Subject: MHI's Response to US-APWR DCD RAI No. 289-2217 REVISION 1

Reference: 1) "Request for Additional Information No. 289-2217 Revision 1, SRP Section: 05.02.03 - Reactor Coolant Pressure Boundary Materials, Application Section: DCD Tier 2, Section 5.2.3" dated March 25, 2009.

**US-APWR Design Certification
Mitsubishi Heavy Industries
Docket No. 52-021**

RAI NO.: NO. 289-2217 REVISION 1
SRP SECTION: 05.02.03 - REACTOR COOLANT PRESSURE BOUNDARY MATERIALS
APPLICATION SECTION: 05.02.03
DATE OF RAI ISSUE: 3/25/2009

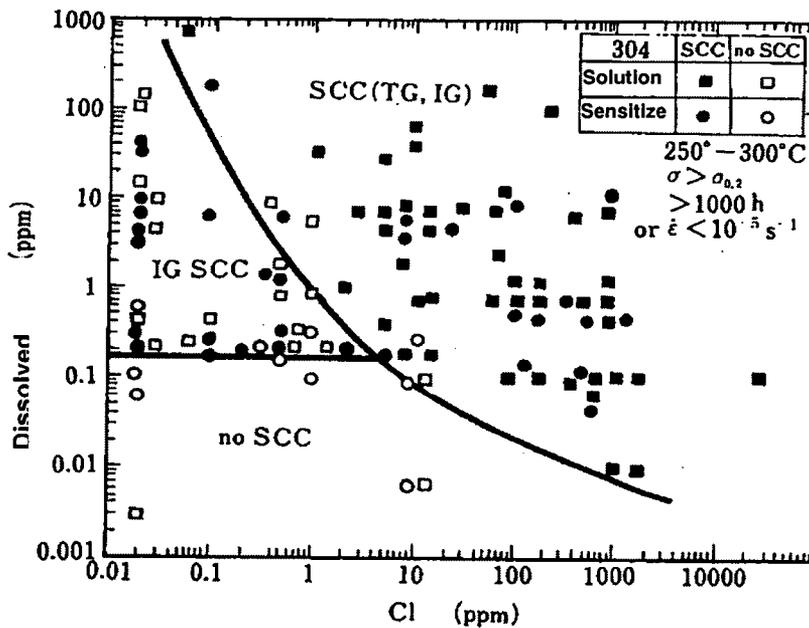
The applicant has listed standard grades of stainless steels (non-low carbon) in Table 5.2.3-1. The staff requests that the applicant specify its maximum carbon content for all austenitic stainless steels, other than cast materials, used in the RCPB. If the maximum carbon content is greater than 0.03%, provide a justification for the use of these materials given that such materials may be susceptible to stress corrosion cracking. The maximum carbon content should be included in Table 5.2.3-1.

MHI understands that low-carbon austenitic stainless steel is a better choice of material because of its higher resistance to stress corrosion cracking even in the PWR environment. On the other hand, strength properties of low-carbon austenitic stainless steel are lower than that of the standard grade stainless steel. LN grade stainless steels contain low-carbon content, but have the equivalent strength of standard grade 304/316 materials by adding Nitrogen. The basic policy for austenitic stainless steels in reactor coolant pressure boundary of US-APWR is to select LN grade materials permitting market conditions and availability at the time of procurement.

Material procurement for the forging F316LN austenitic stainless steel is available and F316LN pressure forging materials will be used in RCPB components. Regarding other materials such as piping and tubing materials, LN grade materials are not yet available because of difficulties in manufacturing. Therefore, standard 304/316 grade materials are selected, instead of low-carbon (and standard Nitrogen content) stainless steel, because the loss of strength properties is not preferable. If the LN grade materials become available, MHI will select LN grade austenitic stainless steel piping or tubing materials.

The NRC position in the RG 1.44 is based on the BWR environment condition. Dissolved oxygen in the primary water is controlled under 0.1ppm. The standard value of the dissolved oxygen is 0.05ppm, as discussed in the DCD Table-5.2.3-2. This dissolved oxygen area is under the limit of SCC environment condition. The following figure shows the relationship between SCC potential and chemical condition of dissolved oxygen and chloride ion by M. O. Speidel, which was presented at the 1st U.S. – Japan Joint Symposium on Light Water Reactors, Fuji, Japan (1978). The chemical conditions of the US-APWR primary water is in the no SCC area – below the curve.

In existing PWR plants, pressure boundary piping is made from Type 316 stainless steel, and reactor internal structures are made from Type 304 stainless steel. These materials do not experience SCC phenomenon, which supports the following data.

Therefore it is MHI's position that low carbon stainless steel is not necessary in the primary water of the PWR.
